Contract #: 04-0120F4Cty: SF/ALA Rte: 80 PM: 13.2/13.9File #: 69.25B**QUALITY ASSURANCE -- NON-CONFORMANCE REPORT****Location:** Changxing Island, Shanghai, P.R. China**Report No:** NCR-000694**Prime Contractor:** American Bridge/Fluor Enterprises, a JV**Date:** 10-Mar-2010**Submitting Contractor:** Zhenhua Port Machinery Company, Ltd (ZPMC), Changxing Island**NCR #:** ZPMC-0661**Type of problem:**

Reference Description: Missed UT indication by QC on Segment 9AE Side Panel**Description of Non-Conformance:**

To:	AMERICAN BRIDGE/FLUOR, A JV 375 BURMA ROAD OAKLAND CA 95607	Date:	14-Mar-2010
Dear:	Mr. Charles Kanapicki	Contract No:	04-0120F4 04-SF-80-13.2 / 13.9
Attention:	Mr. Thomas Nilsson Project/Fabrication Manager	Job Name:	SAS Superstructure
Subject:	NCR No. ZPMC-0661	Document No:	05.03.06-000651

Reference Description: Missed UT indication by QC on Segment 9AE Side Panel

WELD NUMBER: SEG050A-003

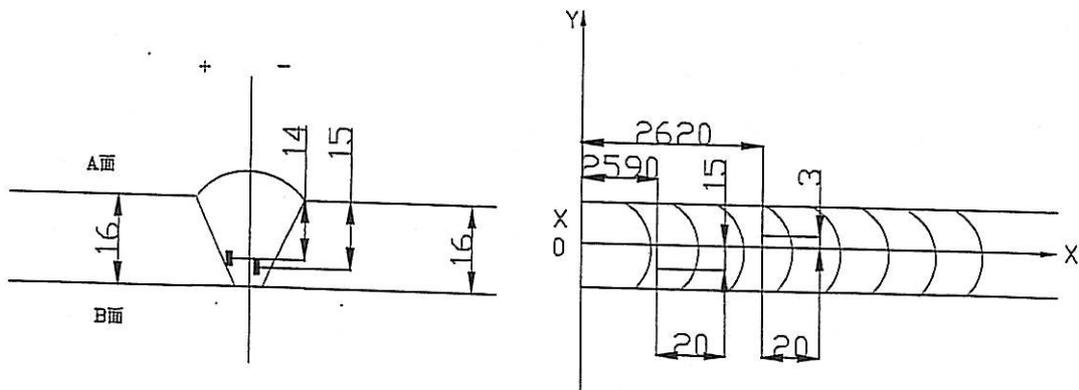
Description of welding discontinuity:

Rejected indication found by ultrasonic inspection is less than the maximum allowance aggregate length.

Caused:

1. Did not clear the weld pass completely in time.

Disposition :

1. Gouge or grind from nearer side from metal edge ($D \leq 0.65T$, "D" is depth of defects, "T" is thickness of metal) to remove all defects;

2. Follow repair WPS for joint preparation, preheat, and weld deposit;

3. Verify with VT no defects remain in the weld joint prior to welding;

4. Grind the repaired area flush with base metal or the adjacent weld;

5. Check the welds according to the working drawings.
